TOWN OF WINCHESTER
PLANNING BOARD MEETING
TUESDAY, FEBRUARY 11, 2020 @7:30PM
SELECT BOARD ROOM

OFF HIGHLAND AVE/ABBY ROAD SUBDIVISION

TO: Winchester Planning Board
FROM: Beth Rudolph, PE, Town Engineer *BER*
DATE: February 6, 2020
RE: Abby Road Subdivision – Request for Release of Lots

Attachment 1

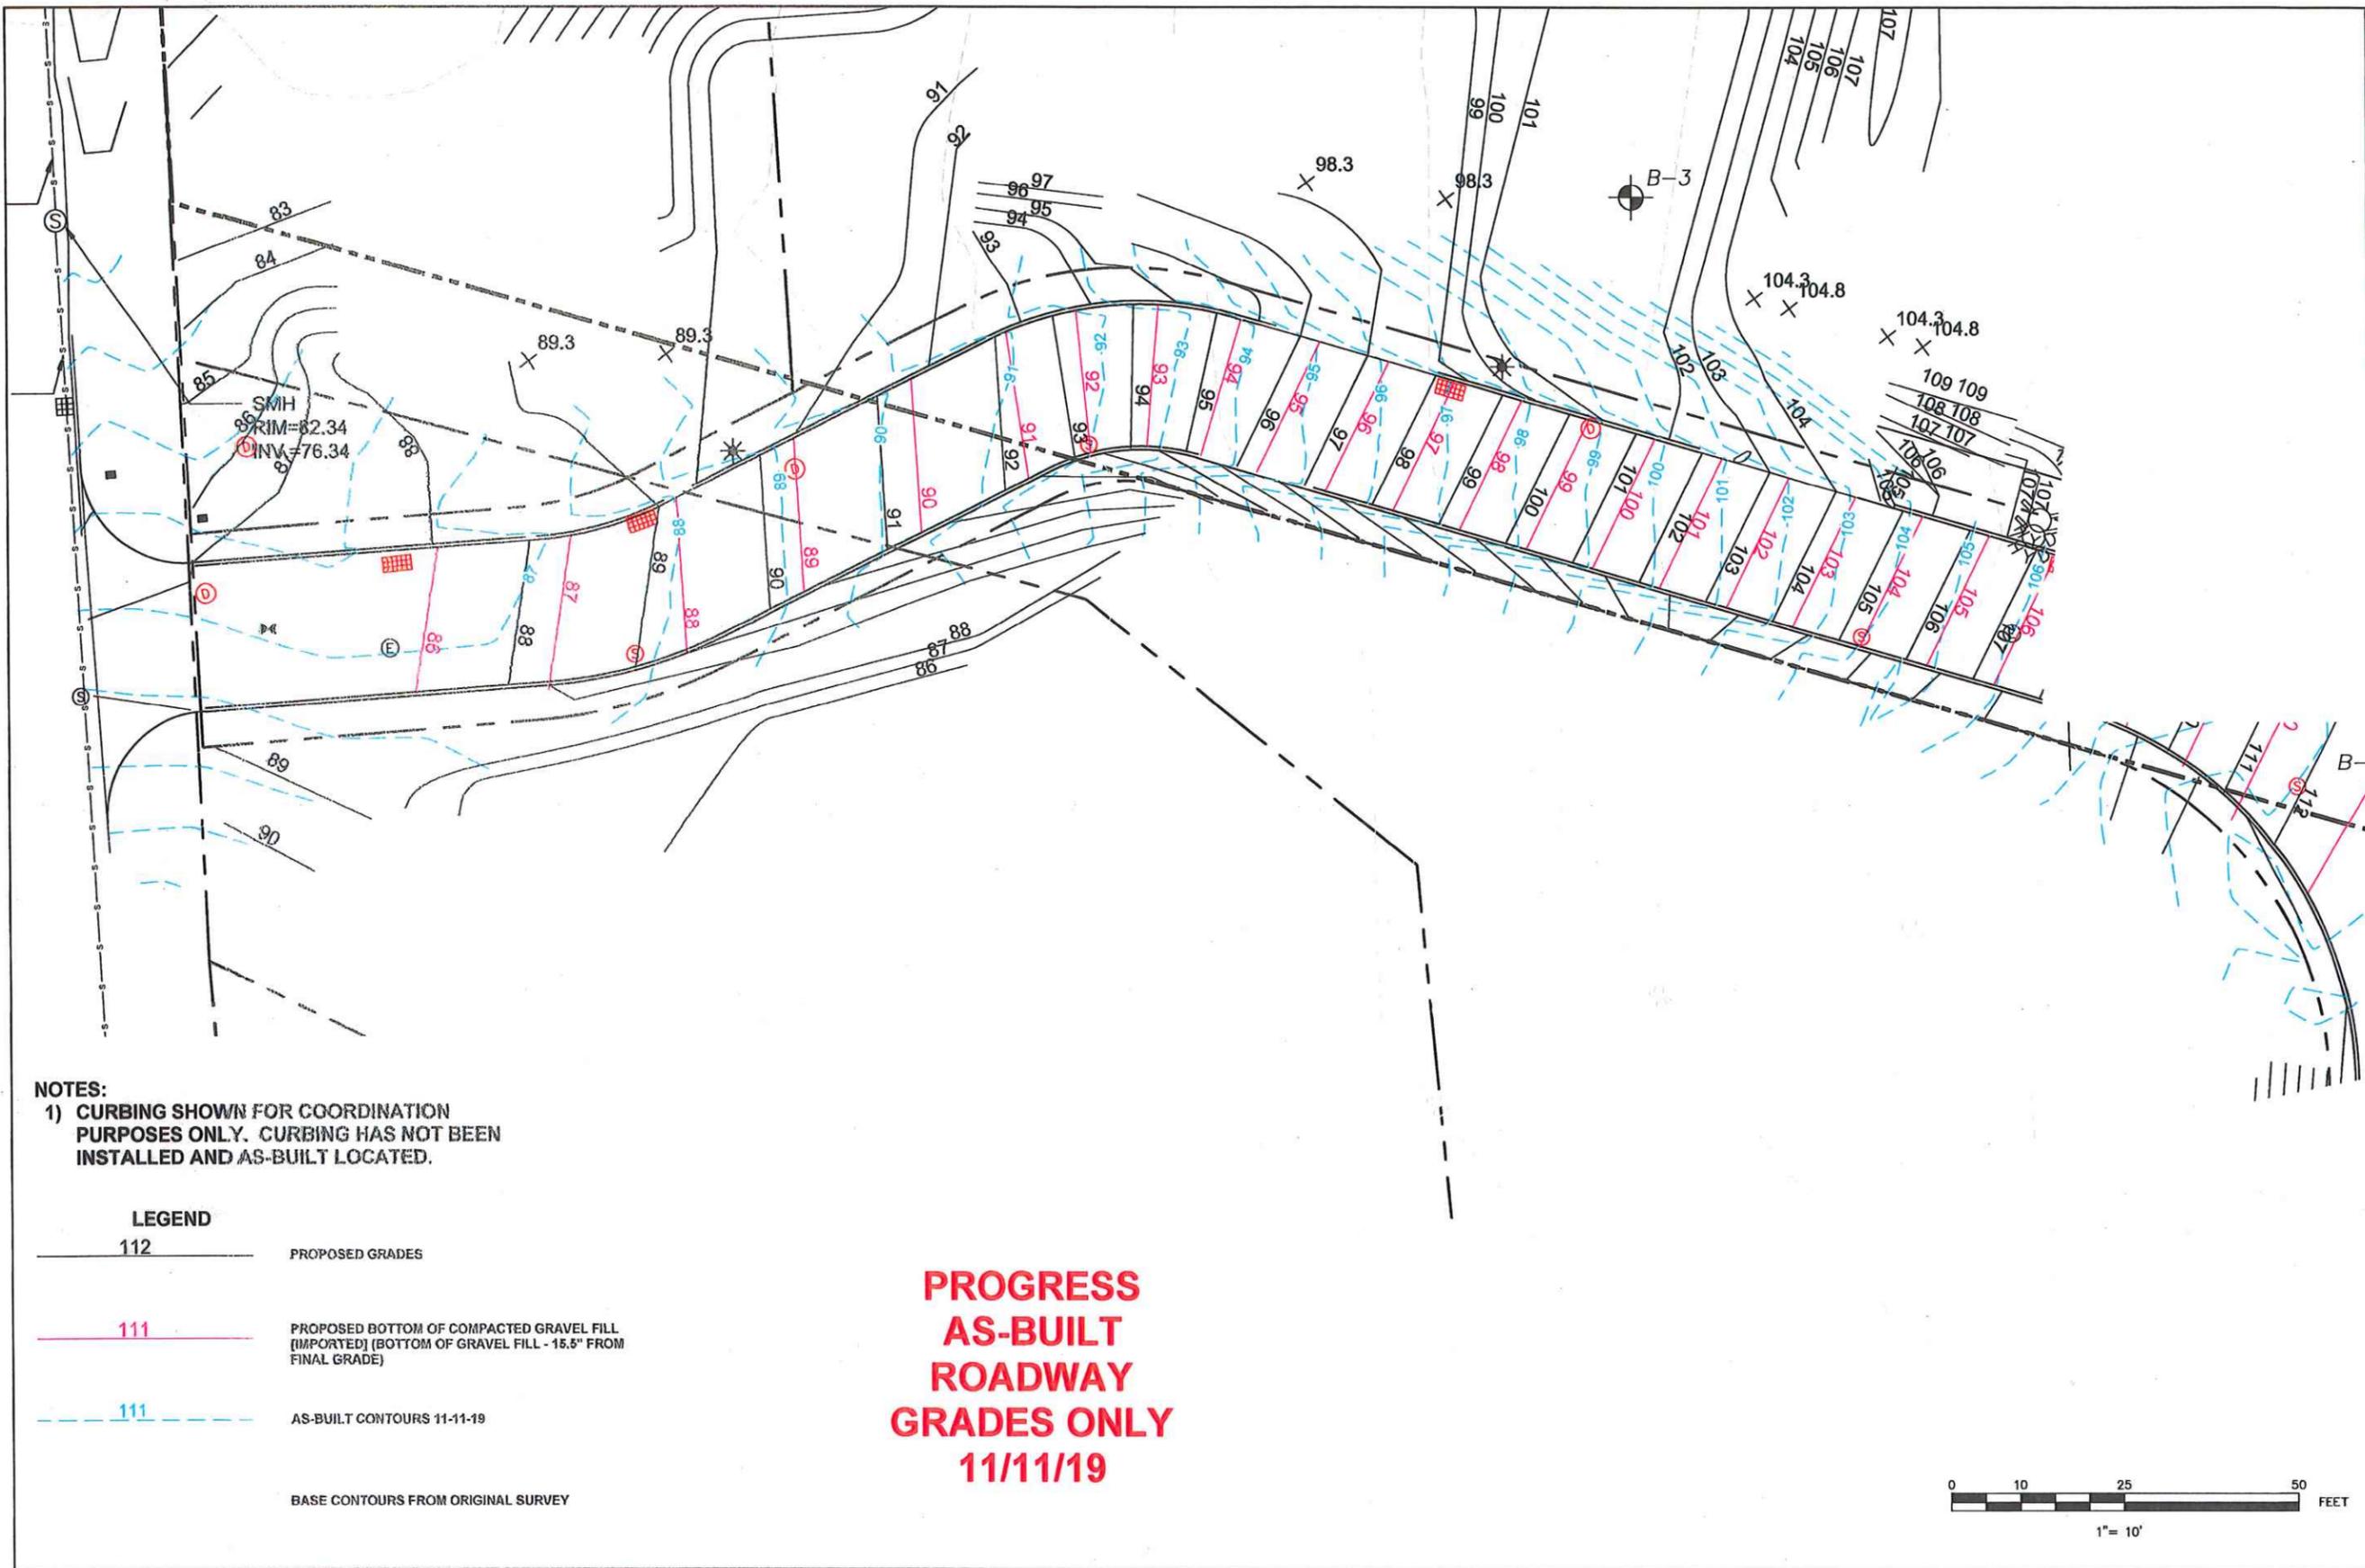
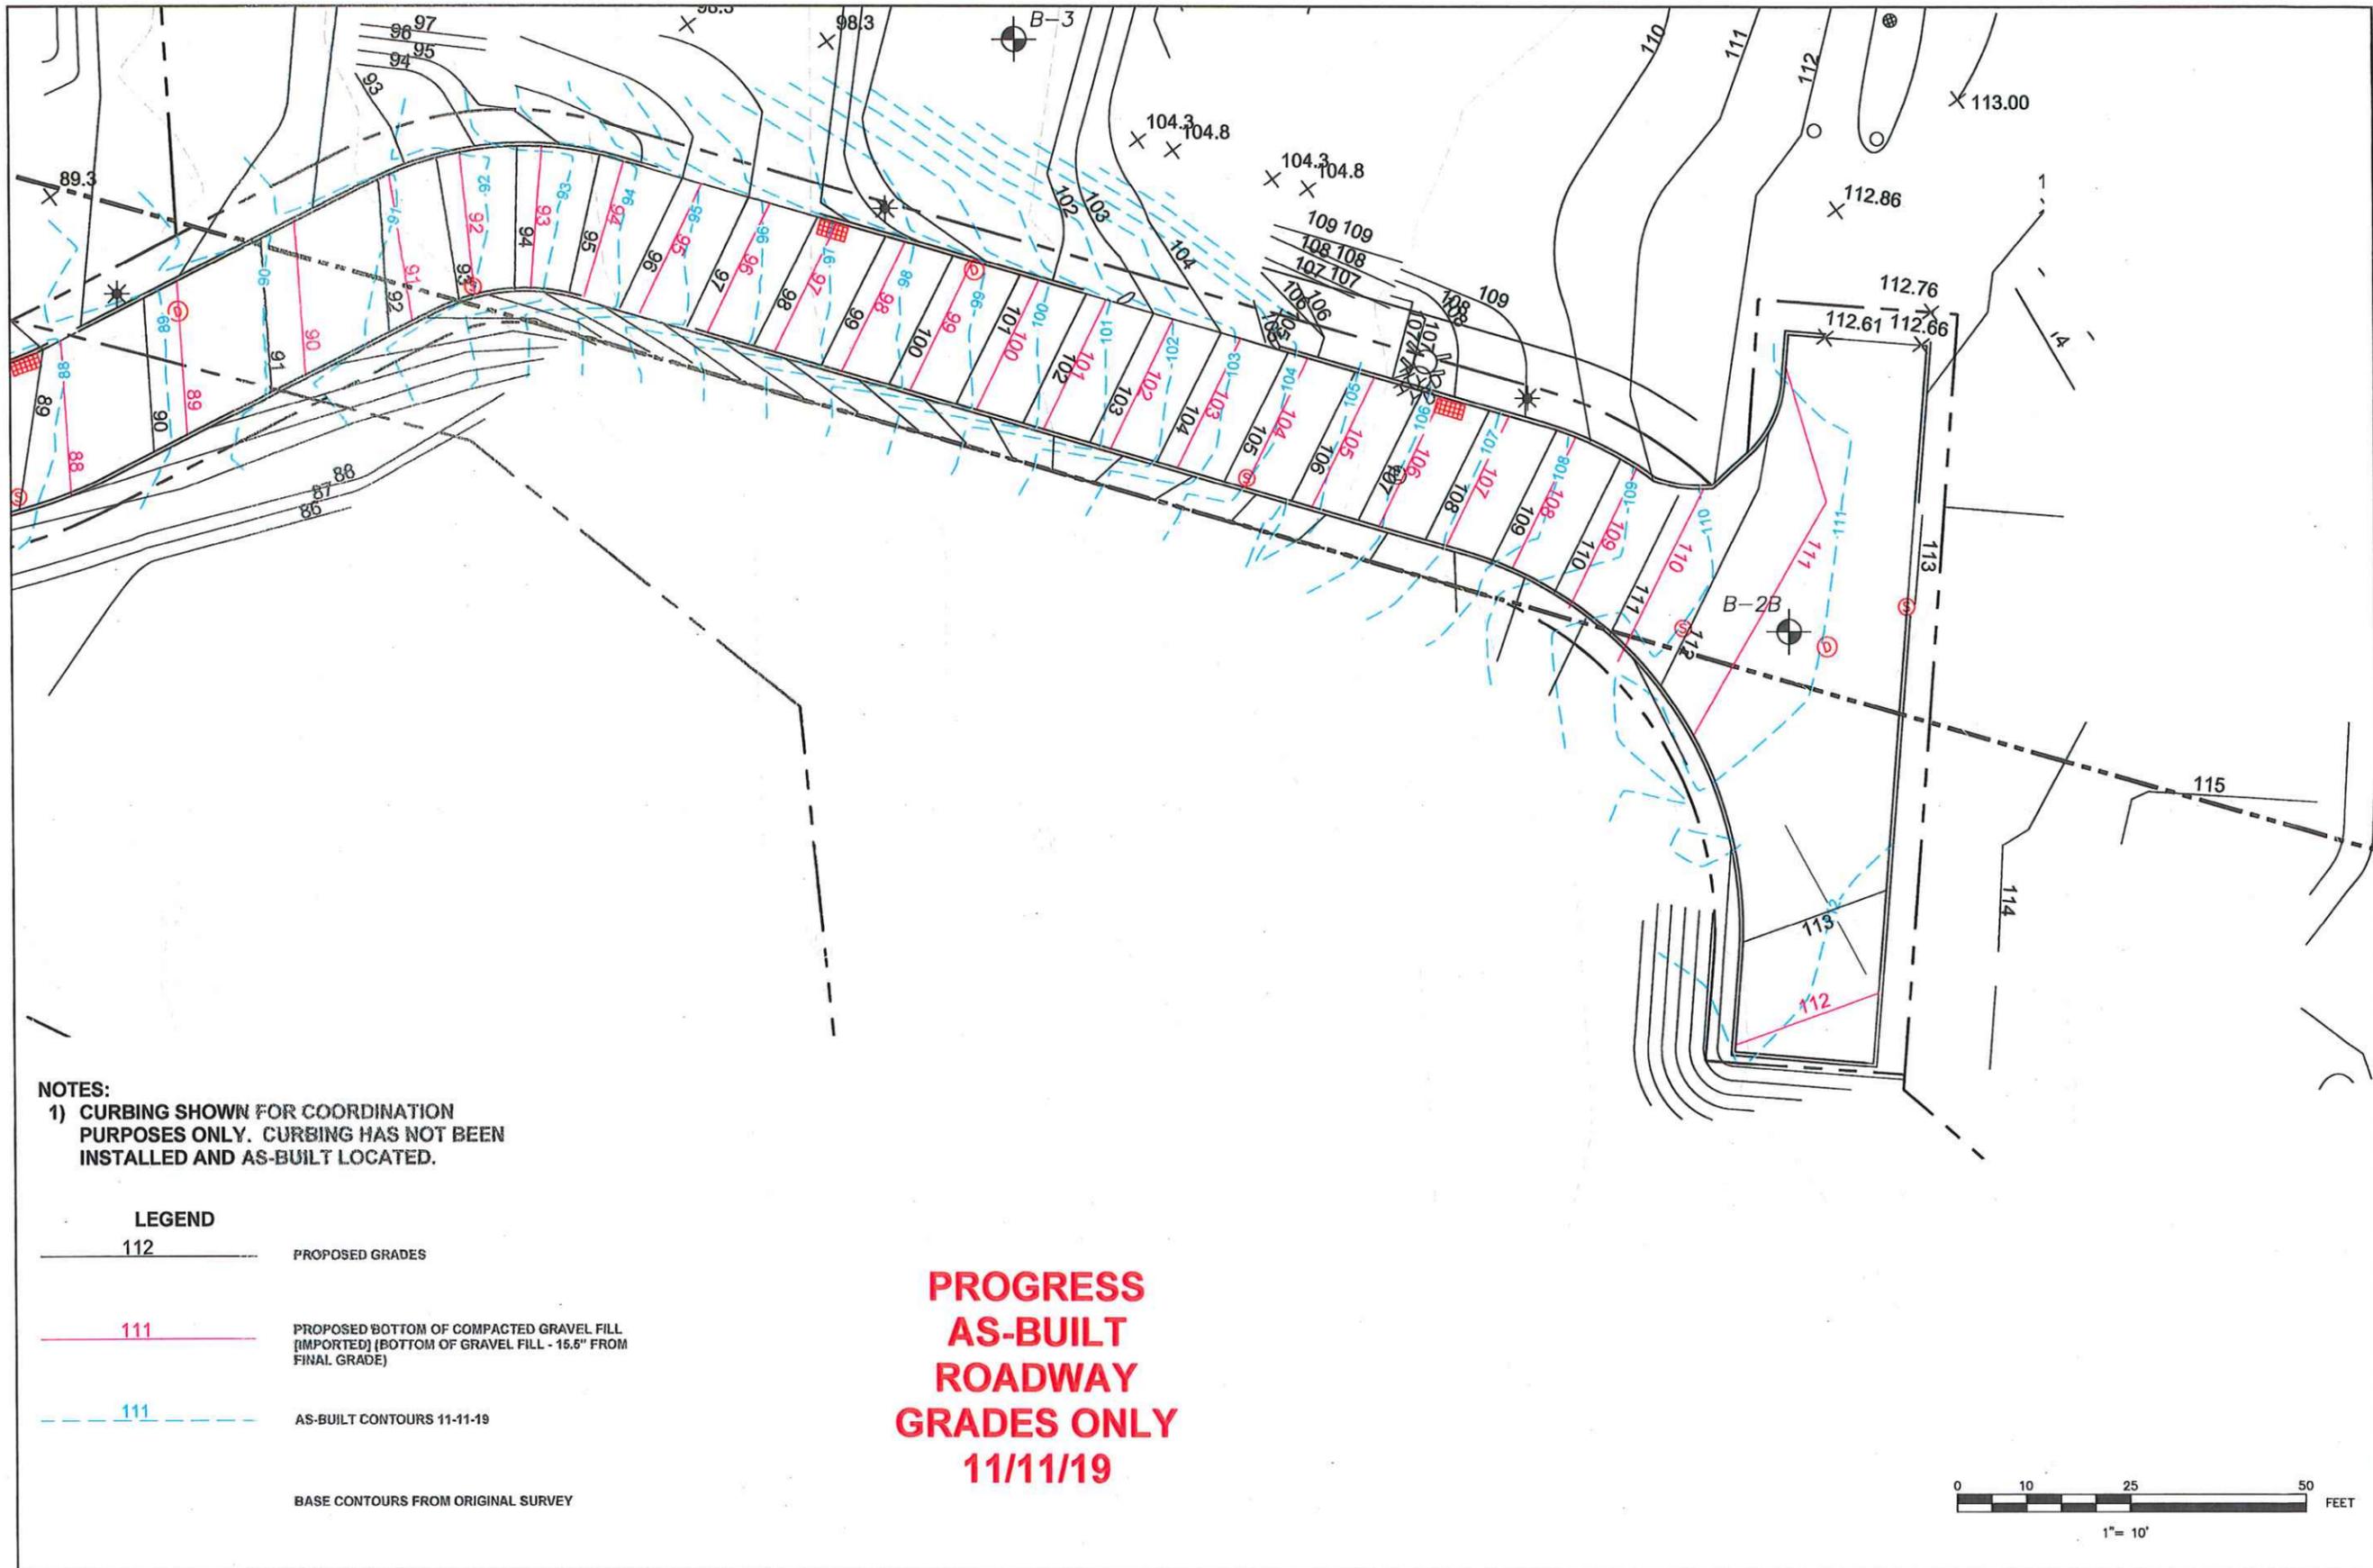
- (5) Interim As-built Plans – Prior to the release of the lots, the applicant should be required to provide an updated interim as-built plan for the project in accordance with the requirements of Section 7.21 of the Subdivision Regulations. The plans must be stamped by a Professional Land Surveyor and Professional Engineer, and include the certifications outlined in Section 7.21.2 of the Subdivision Regulations. Previous interim as-built plans were received on September 30 and November 11, 2019 (Attachment 1), but were not stamped nor did they include this certification.

Attachment 2

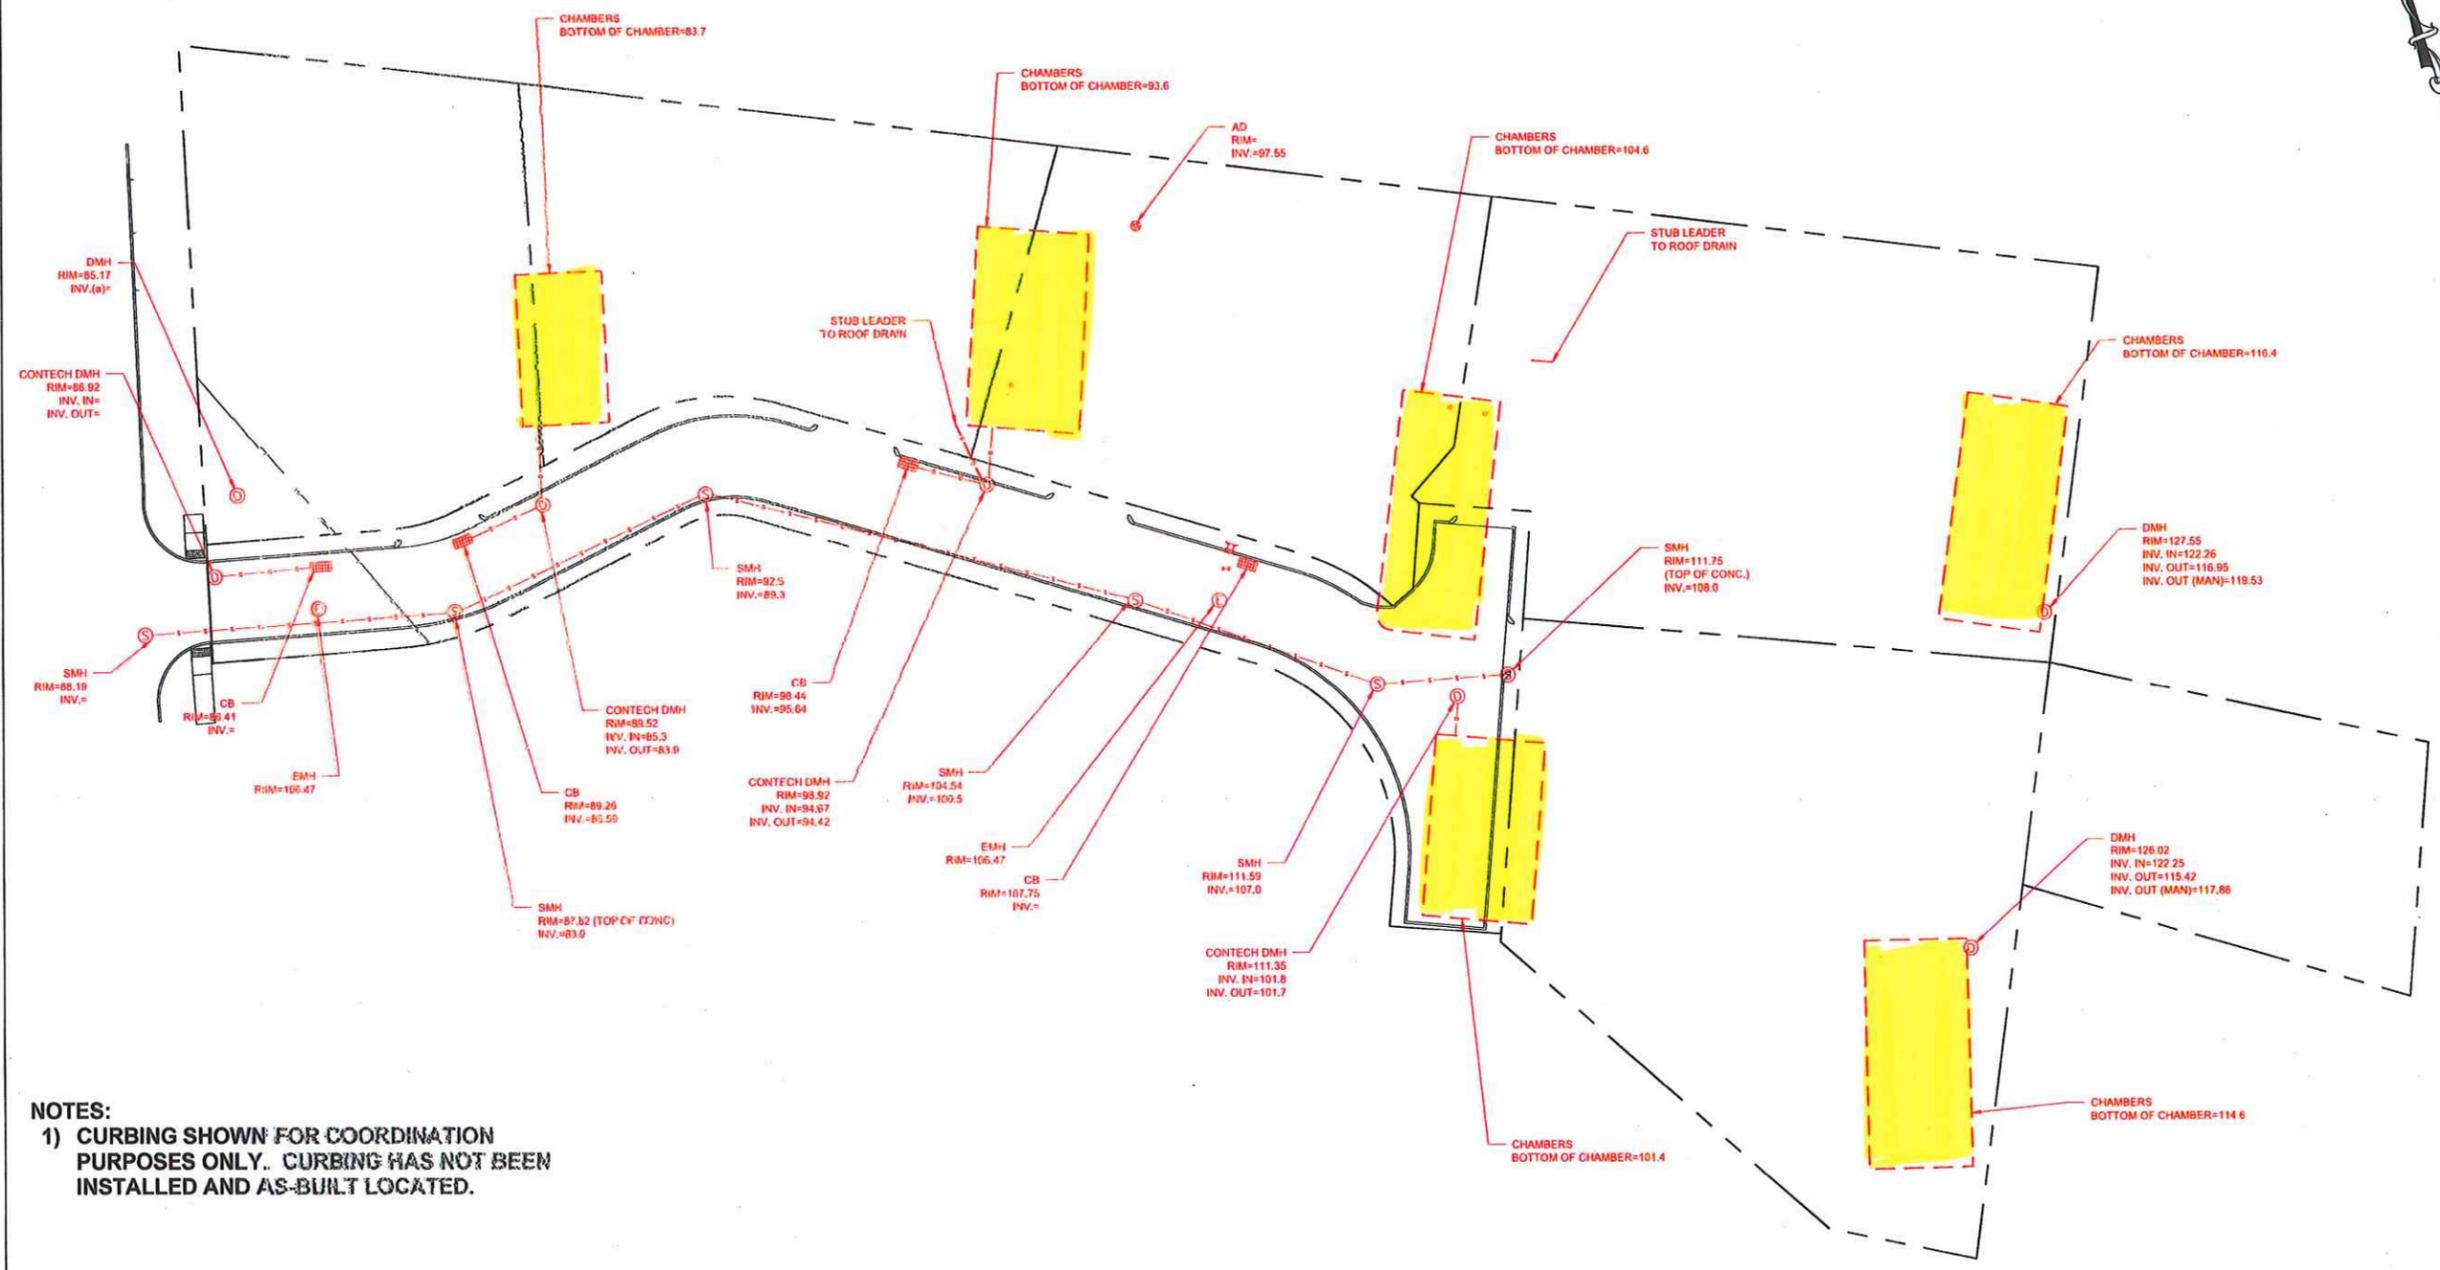
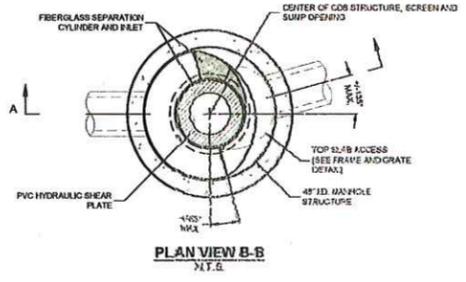
- (6) Utility Easements – Over the past year, the applicant has made several changes to the design of the underground infiltration systems associated with the project. These changes were previously approved by the Engineering Department. Comparing the as-built plans provided on September 30, 2019 to Sheet S-1 of the approved subdivision plans, it appears that the infiltration systems have not all been installed fully within the easement areas laid out in the approved plans. The applicant should provide the Engineering Department with a plan overlaying the as-built location of the infiltration systems and other utilities on Lots 1 – 5 with the utility easements shown on Sheet S-1 (Attachment 2) of the approved subdivision plans. If the infiltration systems as constructed do not fit within the boundaries of the utility easements shown on the approved subdivision plans, the applicant will need to file new plans at the registry updating the easement boundaries. The Engineering Department recommends that this be completed before any impacted lots are released so that the deeds for sale of the lots reflect the correct utility easement locations.
